CITY OF CEDARBURG
A JOINT MEETING OF THE COMMON COUNCIL & PLAN COMMISSION
MONDAY, JUNE 15, 2026 – 7:00 PM

A. Review, discussion, and consultative feedback to applicant Neumann Developments, Inc. regarding a concept subdivision plat for single-family residential development of 214 acres of land located at the north-west corner of Hwy. 60 and Sheboygan Road (C.T.H I). This property is presently owned by Airport View LLC and Covered Bridge Fields LLC.

PLANNERS REPORT

CONCEPT PLAN Covered Bridge

CONCEPT PLAN "COVERED BRIDGE"
STH 60, Cedarburg, Wisconsin

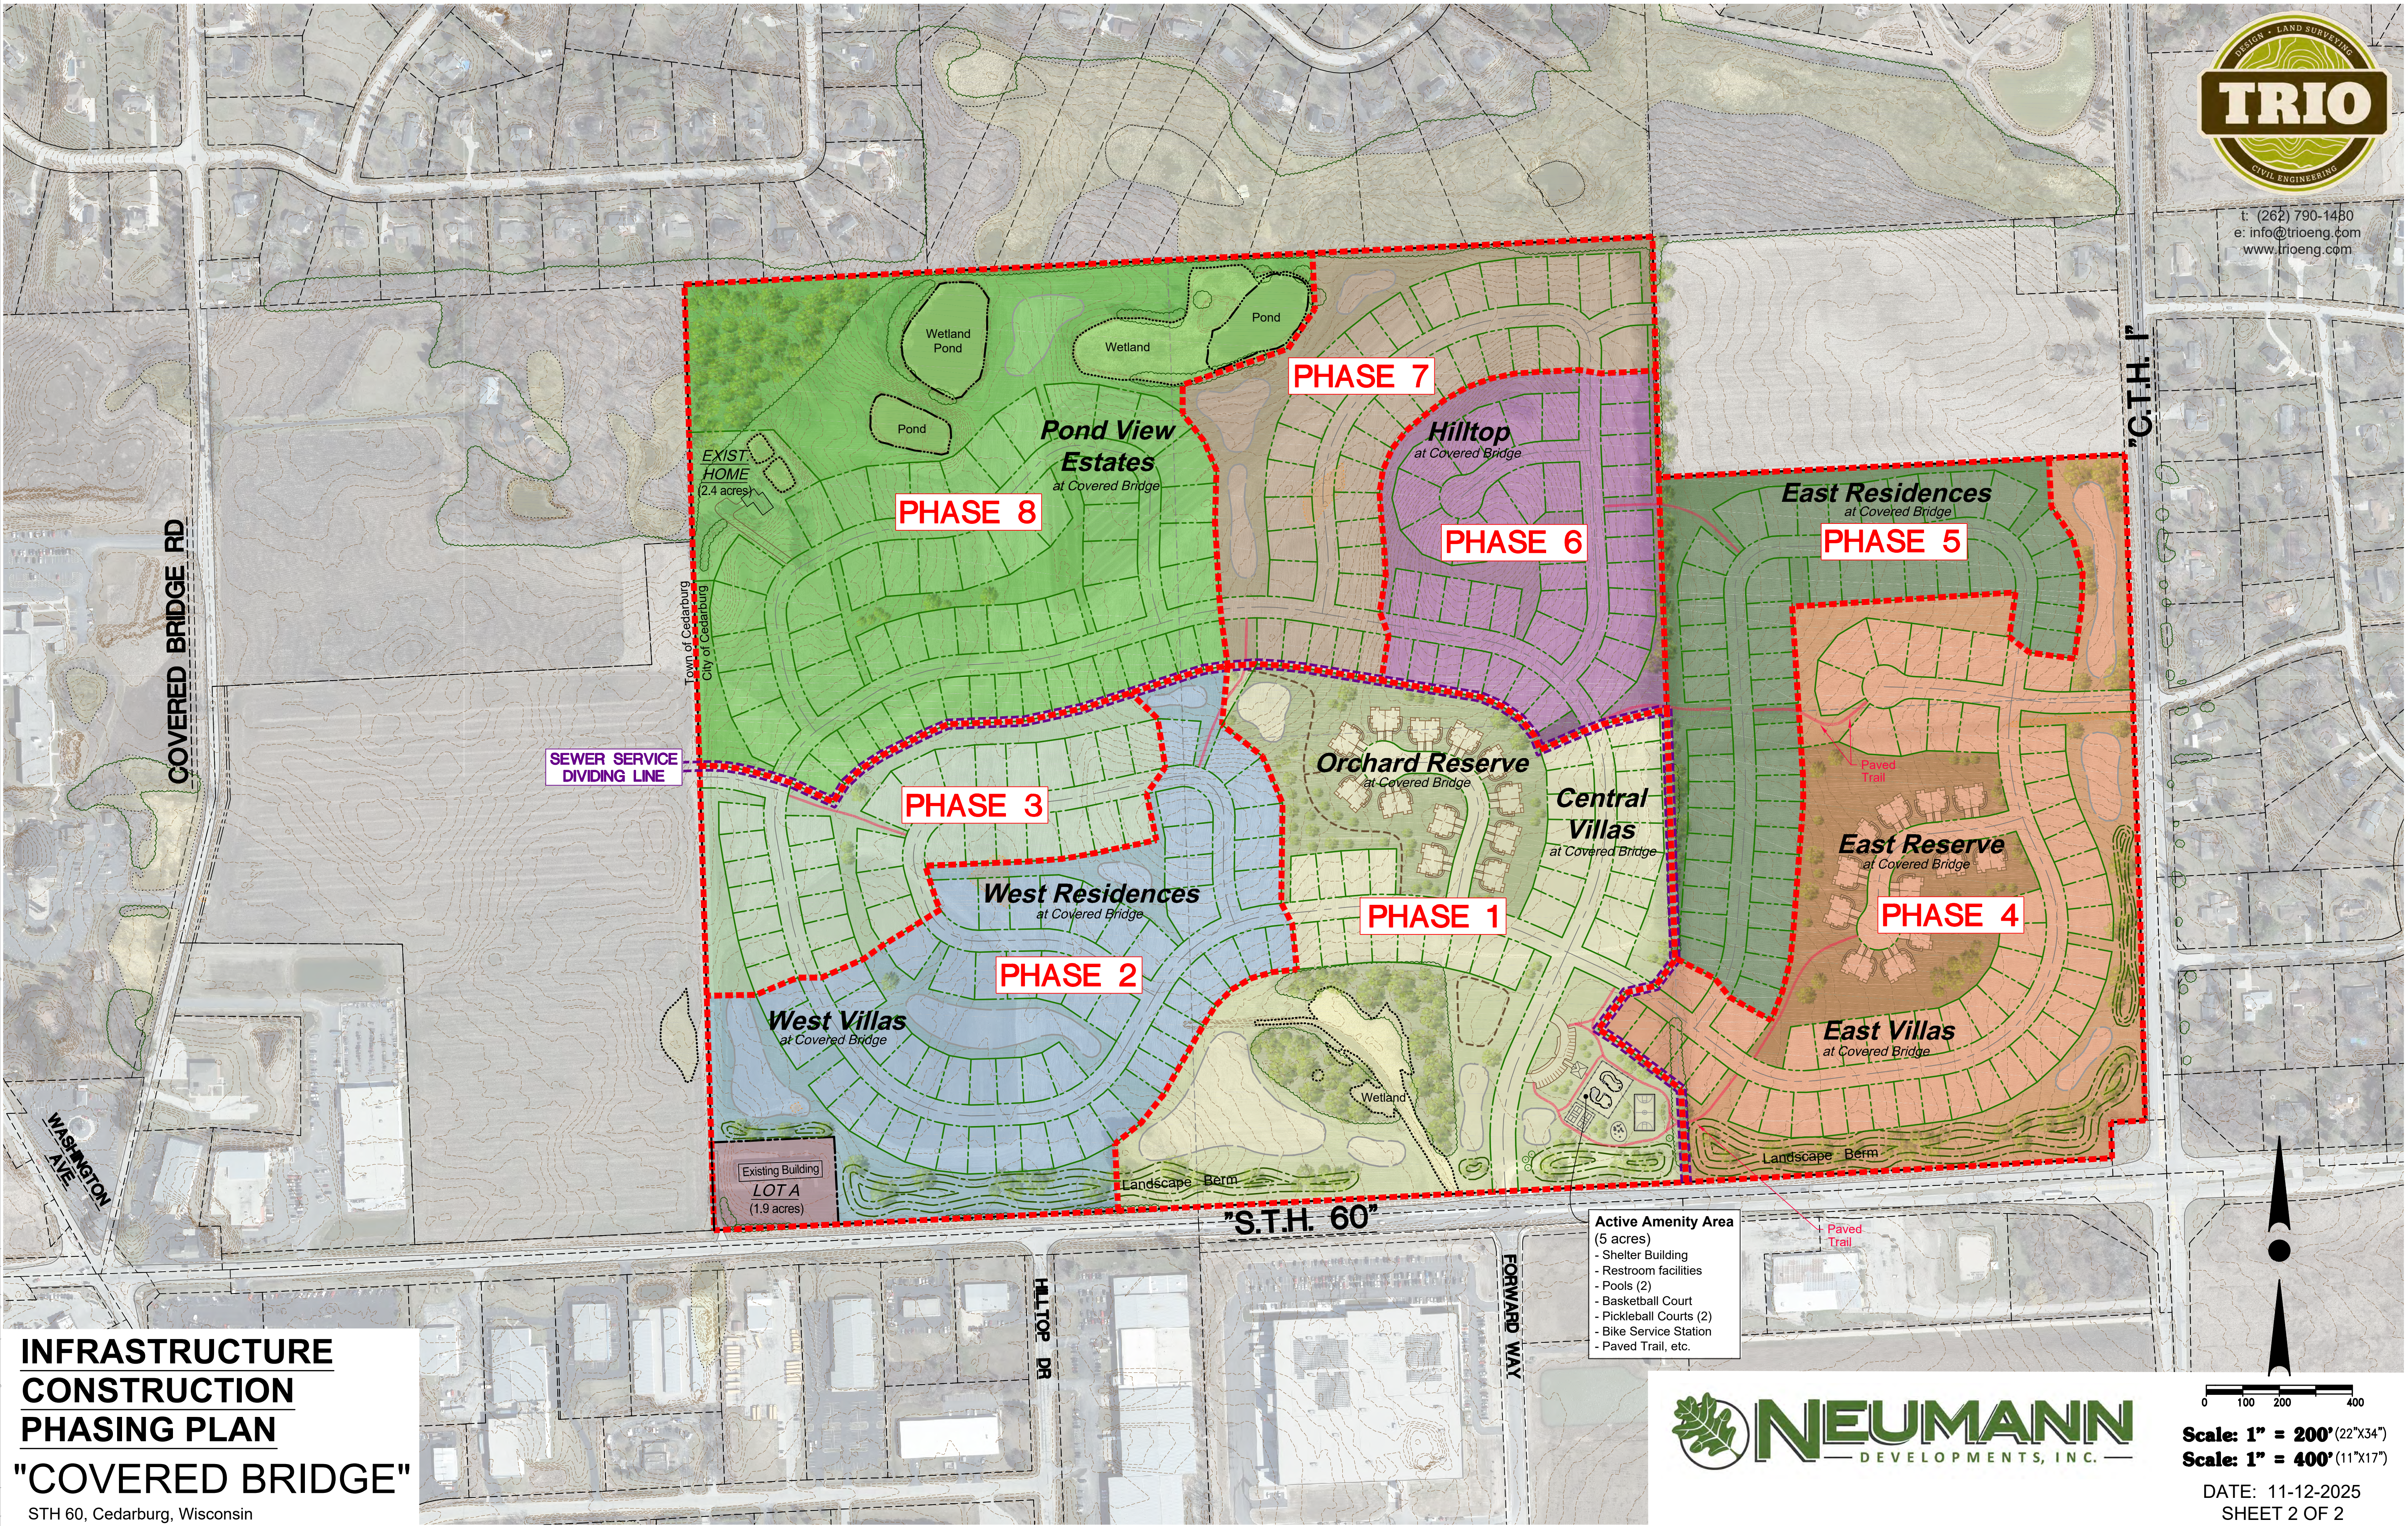
Commission members discussed several important aspects of the development. They highlighted the need for homes to have a more distinctive appearance, moving away from garage-dominant facades. They proposed making front porches functional, with

minimum dimensions of 6 feet by 10 feet, vs. small porches for decoration only.

Chairperson Voltz suggested creating a road hierarchy similar to that of Cedar Pointe and utilizing existing topography to enhance neighborhood interest and experience. Avoid houses from being positioned behind garages. Ensure that utility boxes are well-thought-out in terms of locations.

Architect Rushing emphasized the importance of having a buffer for Highway 60, suggesting that it should not be merely a screen or berm to hide the development, but rather an aesthetic enhancement. Boulevards might be a nice way to create desirable entries and a hierarchy of streets. Utilizing different builders (vs a builder's finite book of plan choices) could help diversify home designs and be more reflective of Cedarburg. Commissioner Arnett expressed a desire for the community to be interconnected with the trails along Highway 60. Additionally, this development is almost completely single-family residential, which aligns with the public's preferences as heard during recent Comprehensive Plan update meetings.

Master Site Plan
Covered Bridge

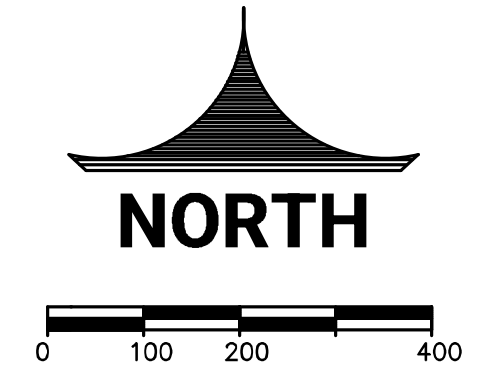
Council member Burkart opposed the fourplexes, while Mayor Thome does not agree with the added dwellings adding to the density of the development. This new plan calls for 499 dwelling units vs 403 in the original layout. The developer says they would be very happy to move forward with either of these plans but needs specific feedback so they don't go all-in down the wrong path.

- Stormwater plans should integrate green corridors, while enlarged plan sheets must outline lot and home orientation, berms, and trail alignment.
- A comparative exhibit should show Option A (more fourplexes) versus Option B (reduced density), detailing unit counts and green space.??

- Density perception: Some members remain concerned that fourplexes increase perceived urban density; the developer to provide comparative exhibits showing impacts on green space and vehicle trips.

City Administrator Hilvo recommended proceeding to the Plan Commission concept review with public input sessions; revised materials will be presented for Plan Commission feedback at the next concept review, with SARB and staff to follow up on architectural and streetscape details prior to formal application.
